**CUT/FILL PLAN**
SCALE 1:1500

PROJECT PROPOSED WAREHOUSE DISTRIBUTION AUGUSTA STREET, HUNTINGWOOD EAST, NSW 2148	DESIGNED LDV	DRAWN JB	DATE JUNE '22	CHECKED MW	SIZE B1	SCALE AS SHOWN	CAD REF: C013904.03-SSDA310
--	-----------------	-------------	------------------	---------------	------------	-------------------	--------------------------------

DRAWING TITLE CUT/FILL PLAN	DRAWING No C013904.03-SSDA310	ISSUE D
--------------------------------	----------------------------------	------------

SECTION 5 - CONTINUATION

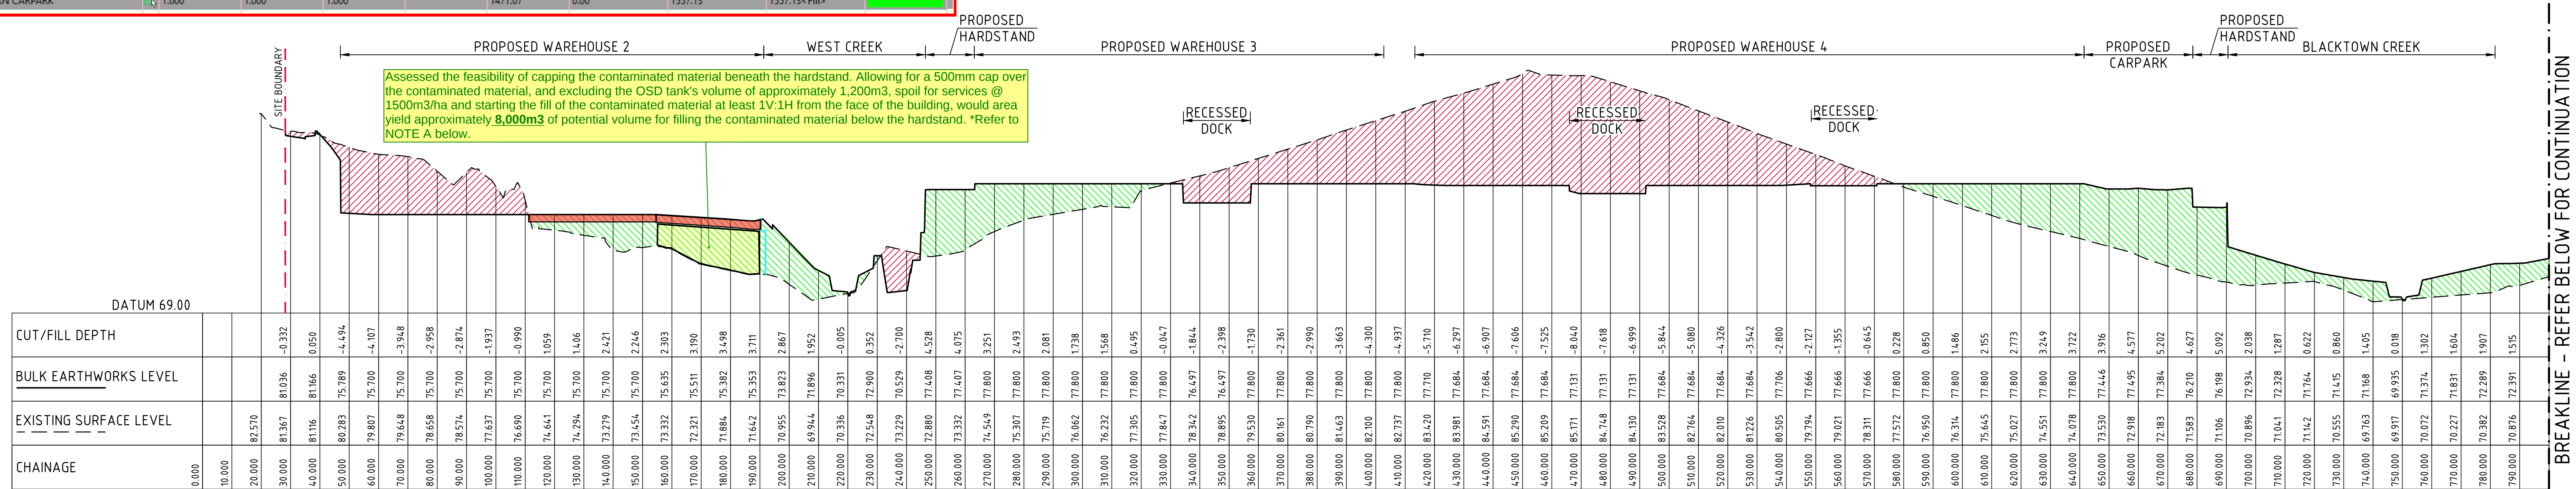
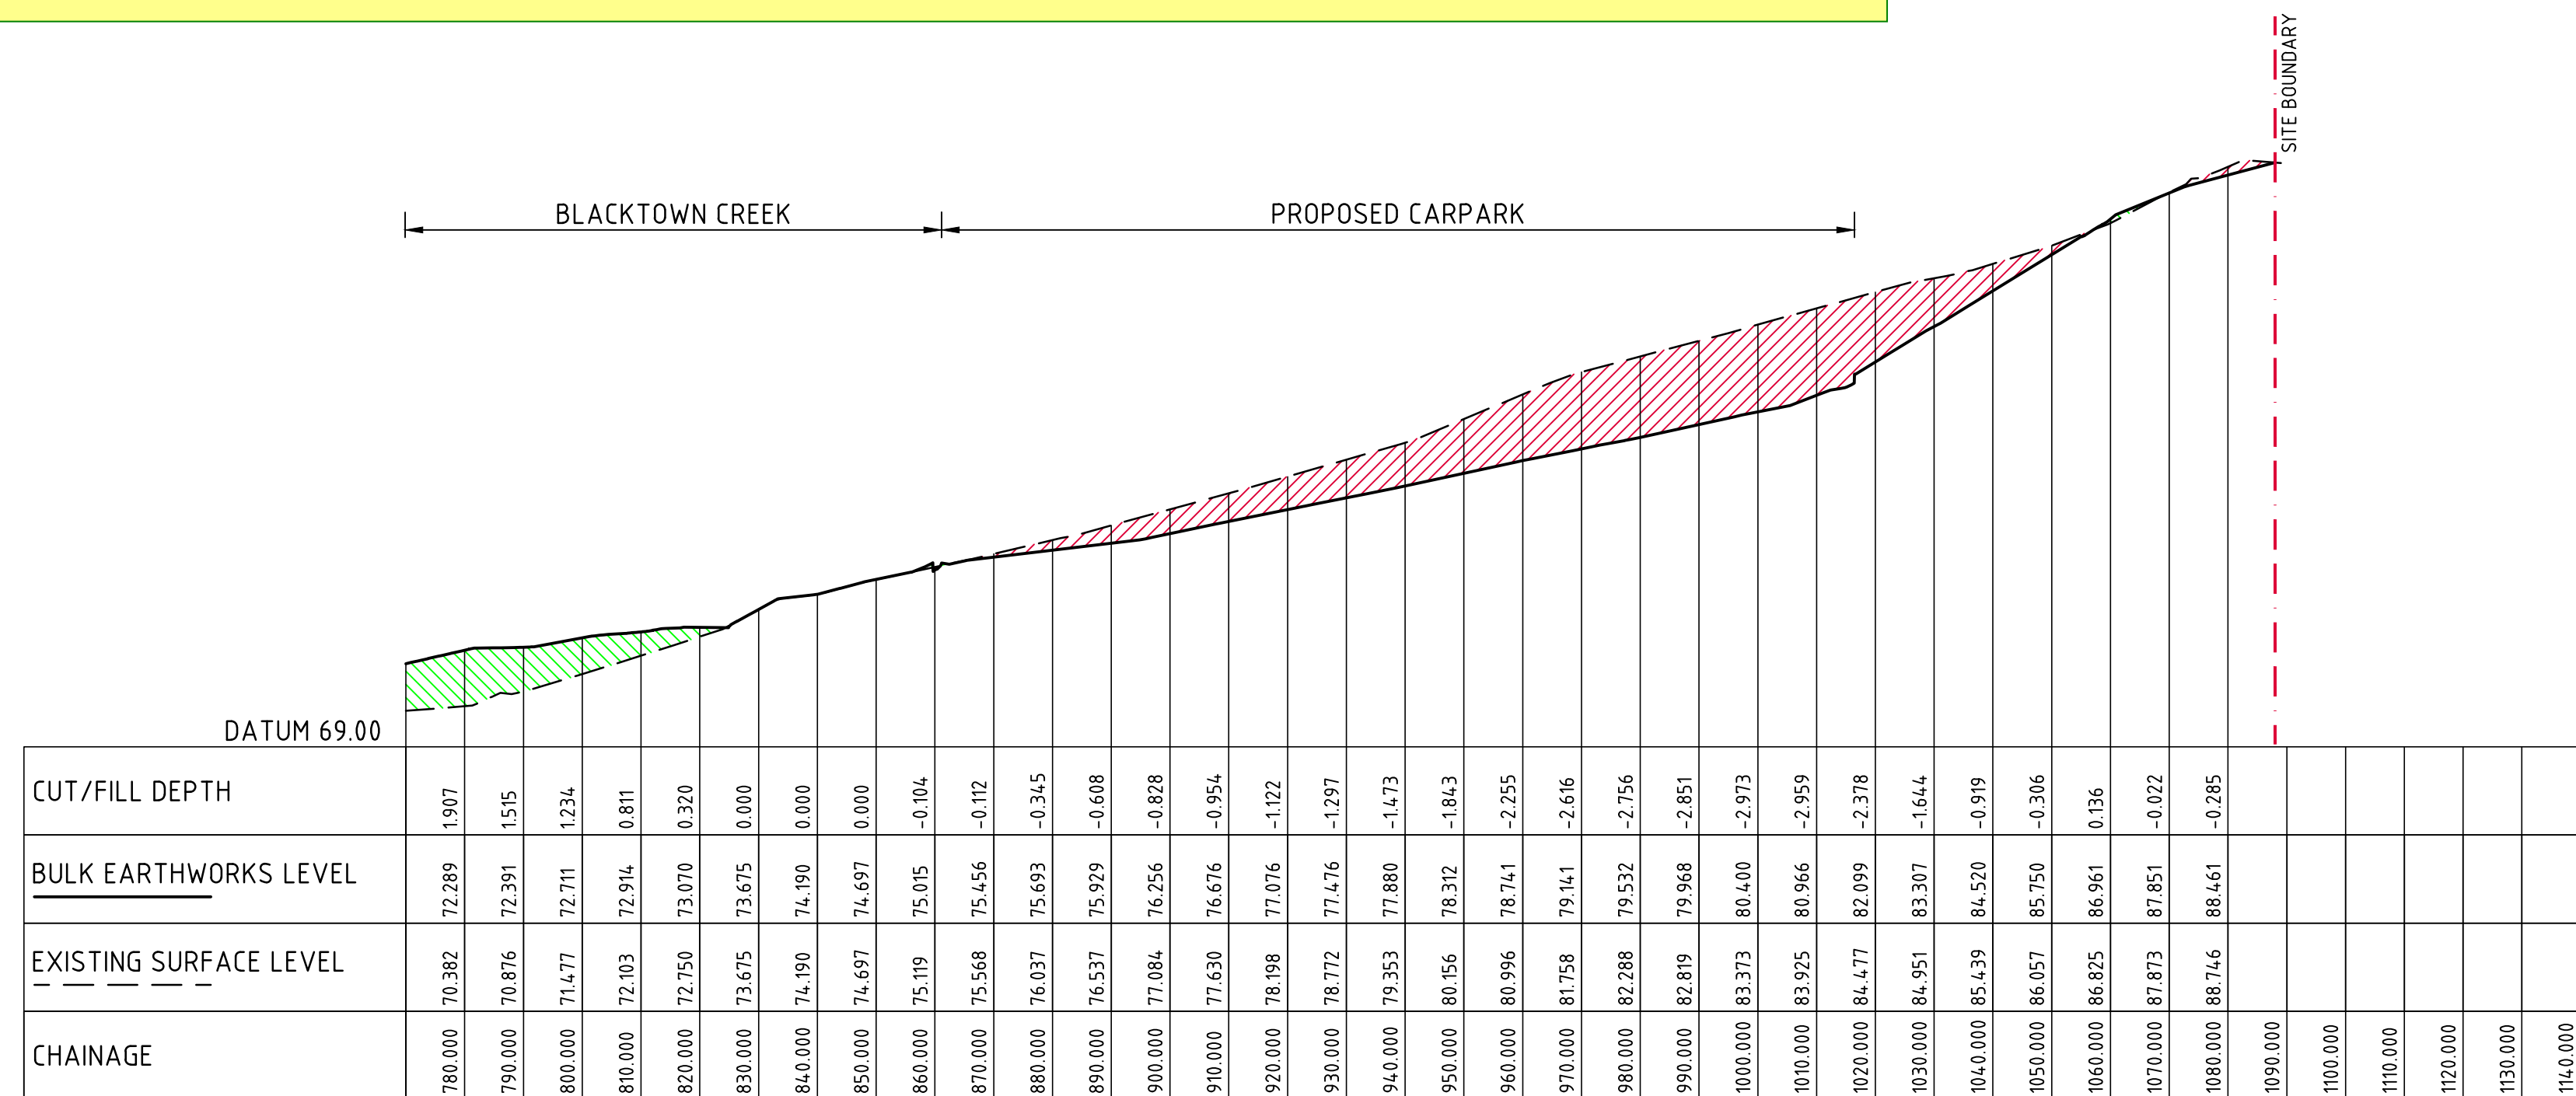
Impacted fill will be managed to the extent achievable via containment and the implementation of permanent physical separation which eliminates the inhalation exposure pathway for airborne asbestos fibres.

The materials to be contained onsite under a marker and capping layer (that comprises 0.5 m of clean capping material and/or hardstand).

No remediation works proposed within the the floodway.

The geotechnical engineer to verify the suitability of the contaminated material for foundation (bearing capacity), provide insights into the long- and short-term modulus (E value) of the soil, -CBR value, guidance on shrinkage and swelling, identification of material type, and related recommendations.

SECTION 6
HORIZONTAL SCALE 1:1000
VERTICAL SCALE 1:200

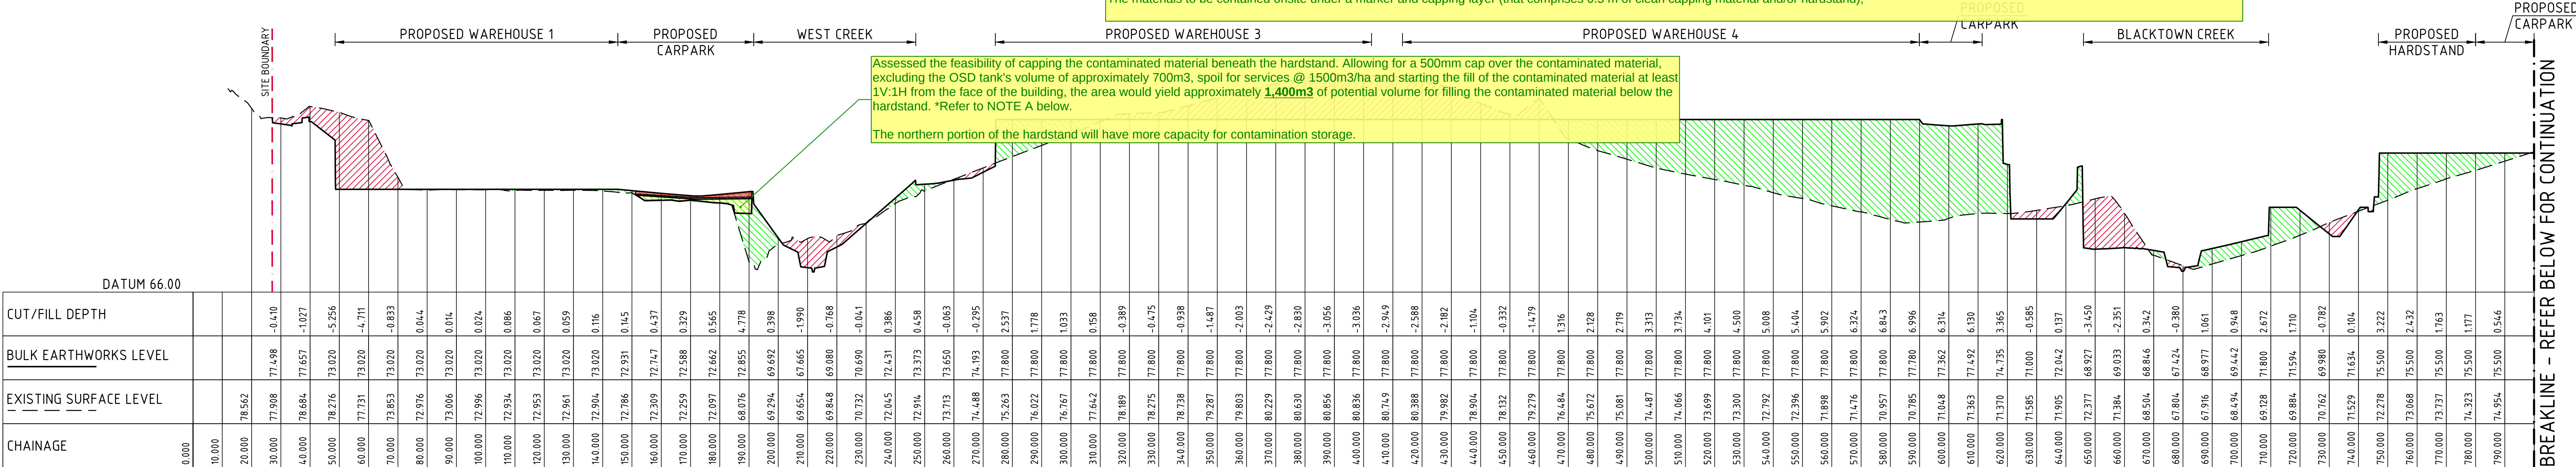
No remediation works proposed within the the floodway.

Impacted fill will be managed to the extent achievable via containment and the implementation of permanent physical separation which eliminates the inhalation exposure pathway for airborne asbestos fibres.

The materials to be contained onsite under a marker and capping layer (that comprises 0.5 m of clean capping material and/or hardstand);

The geotechnical engineer to verify the suitability of the contaminated material for foundation (bearing capacity), provide insights into the long- and short-term modulus (E value) of the soil, -CBR value, guidance on shrinkage and swelling, identification of material type, and related recommendations.
